AMENDMENT OF SOLICITATION/MODIFICATION OF CONTRACT				1. CONTRACT ID CODE NM PFH 45-1(5)	PAGE 1 OF 25 PAGES
2. AMENDMENT/MODIFICATION NO. 0001	3. EFFECTIVE DATE 10-1-2003	4. REQUISITION/PURCHASE REQ. NO.	5. PROJECT NO. (If applicable) NM PFH 45-1(5)		
6. ISSUED BY Federal Highway Administration Central Federal Lands Highway Division 555 Zang Street, Room 259, HFAC-16 Lakewood, CO 80228-1010		7. ADMINISTERED BY (If other than Item 6) CODE			
8. NAME AND ADDRESS OF CONTRACTOR (No., street, county, State and ZIP Code)		(✓)	9A. AMENDMENT OF SOLICITATION NO. NM PFH 45-1(5)		
		✓	9B. DATED (SEE ITEM 11) 9-4-2003		
			10A. MODIFICATION OF CONTRACT/ORDER NO.		
			10B. DATED (SEE ITEM 13)		
CODE	FACILITY CODE

14. DESCRIPTION OF AMENDMENT/MODIFICATION (Organized by UCF section headings, including solicitation/contract subject matter where feasible.)

SACRAMENTO RIVER ROAD

REG	STATE	PROJECT	SHEET NO.	TOTAL SHEETS
6	NM	PFH 45-1(5) SAC. RIVER ROAD	D63	D96

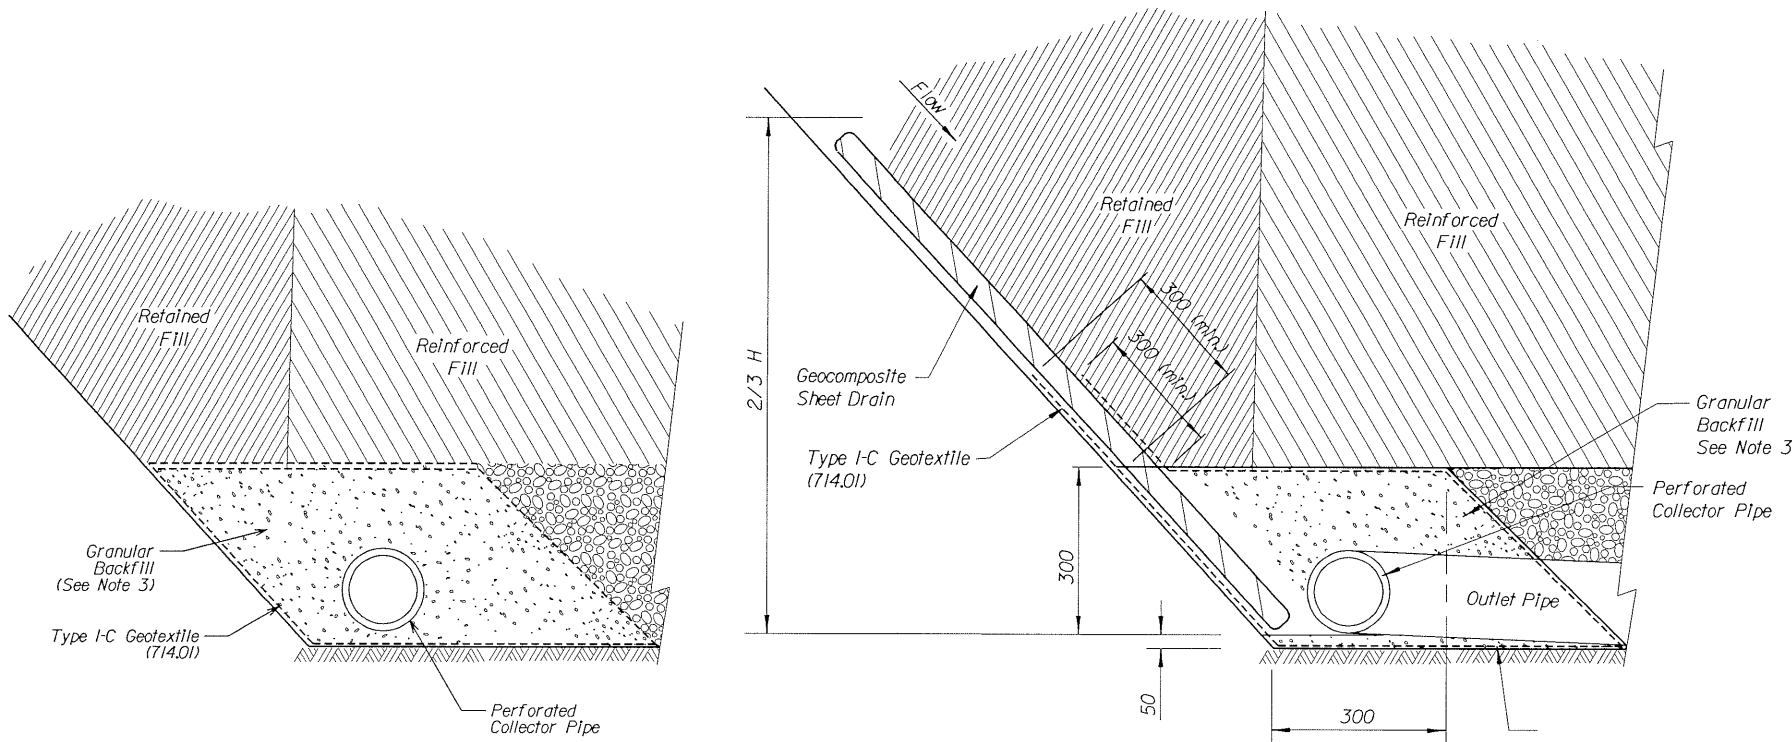
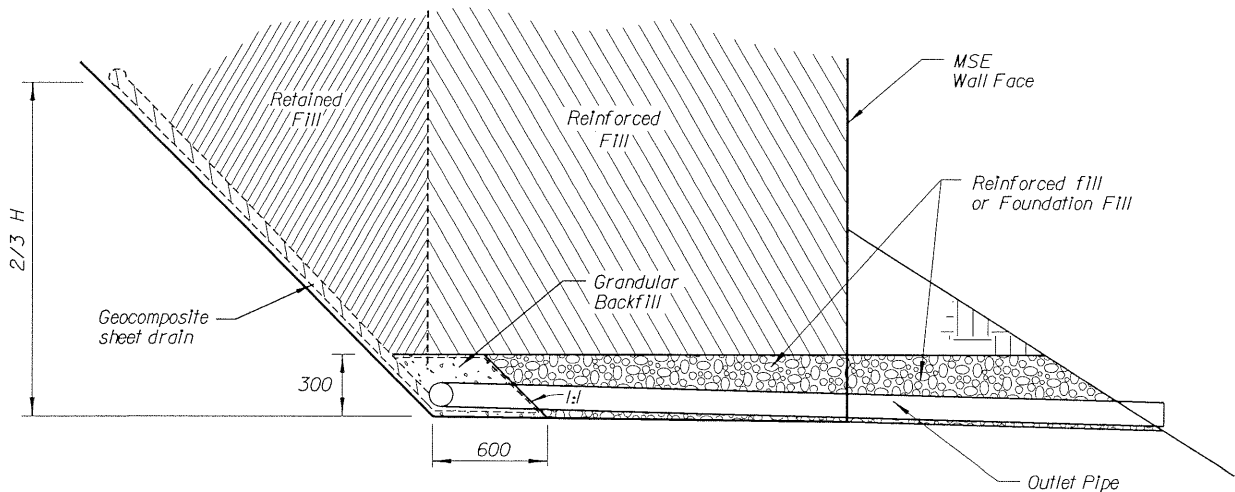
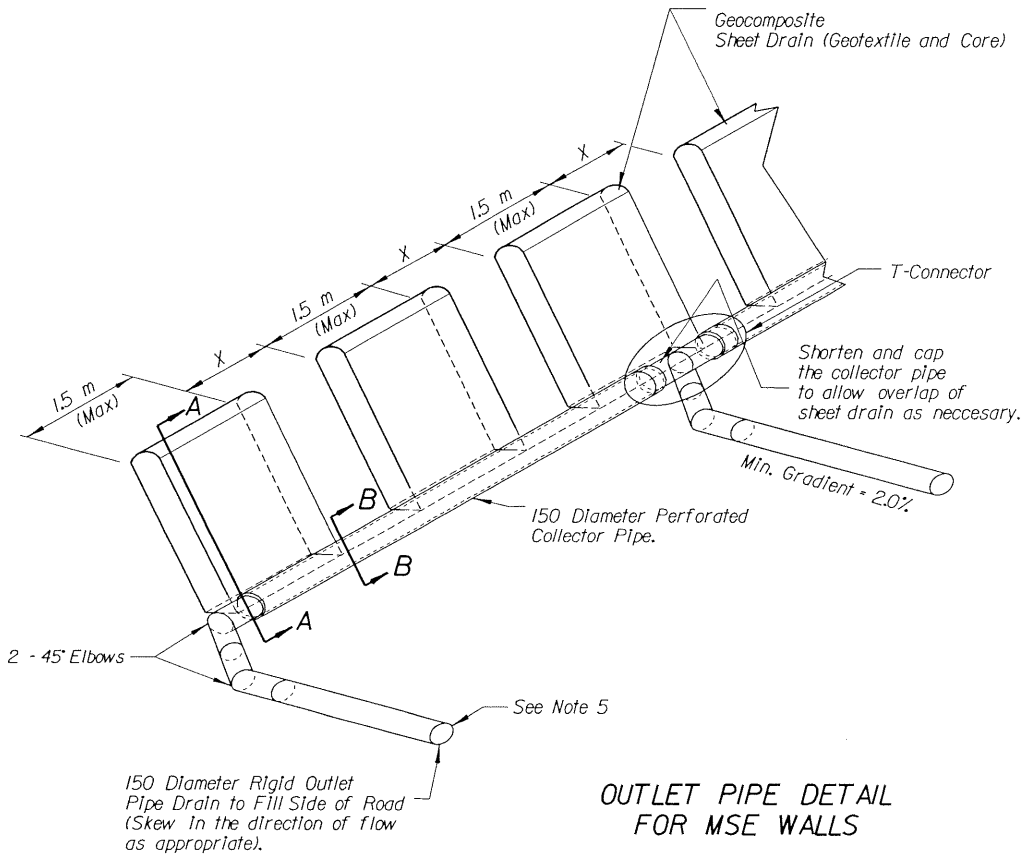
Remove plan sheet D63 and replace with revised plan sheet D63 bearing revision date 10/01/03. Modifies details for additional clarity.

1. Outlet underdrains at lowpoints of wall subexcavation and at 15.0 (max) spacing.
2. Geocomposite Sheet Drains shall be placed in 1.5 m (Max.) wide strips with spacing X to achieve a 30% - 5% coverage (Example; $X = 5.0$ m for a 1.5 m wide stripe).
3. Granular backfill shall meet the requirements of subsection 703.03(a) of the FP 96.
4. Cover the end of the outlet pipe with galvanized 12.7 mm hardware cloth, wire size 1.0 mm. Hold the screen securely in place with standard coupling bands or by other approved means.
5. Mark the outlet of the underdrain with a delineator post or other suitable marker.
6. See Metric Special M255-02 for MSE Wall Typical Section and Details.
7. Geocomposite Sheet Drain shall meet the requirements of subsection 714.02(b).
8. Collector Pipe, Outlet Pipe, and Fittings shall meet the requirements of Subsection 706.08.
